**Historic District Review Committee
Staff Report
Date of Meeting: April 11, 2011
CAPP2011-0005
Historic District: Goose Creek
Project Planners: Lauren Murphy, Heidi Siebentritt**

CAPP 2011-0005 Everline: New Residential Construction in the Goose Creek Historic District. PIN # 386-46-9501.

Figure 1: Subject property, 39009 Hertz Road

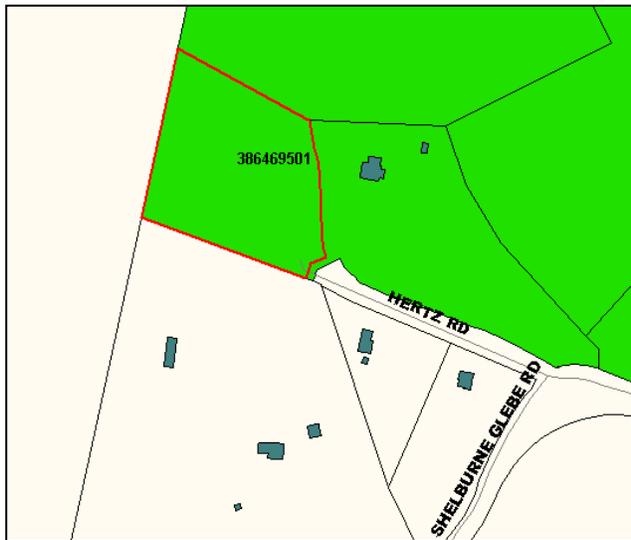
The proposed application seeks to locate a new residential structure on a vacant, wooded lot. The Guidelines recommends minimizing any grade changes and retaining existing trees and other site vegetation to preserve the natural features that define the District (Goose Creek Guidelines, Guidelines for Site Elements, Landforms and Features, page 38, Guidelines 1, 2 & 3). Some of the mature trees on the site have been removed due to storm damage and the location of the drainfield for the house (see statement of justification). However, the trees that were removed from the site have been sawed and prepared as lumber for the new dwelling. The applicants are not proposing any major changes in grade to construct the proposed structure and will maintain the majority of the existing trees. **The application meets the Guidelines for land forms and features.**

The Guidelines state that the siting of a structure should “protect views, especially of natural features” (Goose Creek Guidelines, Guidelines for Site Elements, Siting, page 39, Guideline 1). The proposed structure would be located within a clearing in the existing wooded area on the property. The property is located on a private lane beginning at the dead end of Hertz Road and would not be especially visible from more public thoroughfares such as Shelburne Glebe Road. The Guidelines also state that new construction be sited “according to historic precedents and to take best advantage of weather and views without obstructing historic views” (Goose Creek Guidelines, Guidelines for Site Elements, Siting, page 39, Guideline 2). The applicant’s statement of justification indicates that they have selected the site and the placement of windows on the house to take advantage of natural (and seasonal) sources of heat and light. The front entrance is oriented towards the East which will provide morning sun and afternoon shade on the front porch/deck and vice versa on the rear deck. The Southern exposure of the left side elevation will bring natural light into the residence especially during the winter months. Placing the building in a small clearing within the woods reduces impacts on the existing wooded areas (see map to right) on the property and preserves views from adjacent parcels (Goose Creek Guidelines, Guidelines for New Construction, Building Placement and Setback, page 58, Inappropriate Treatment 1; page 59, Guidelines 1 and 2). **The application meets the Guidelines for siting and building placement as found on page 39 and 59.**
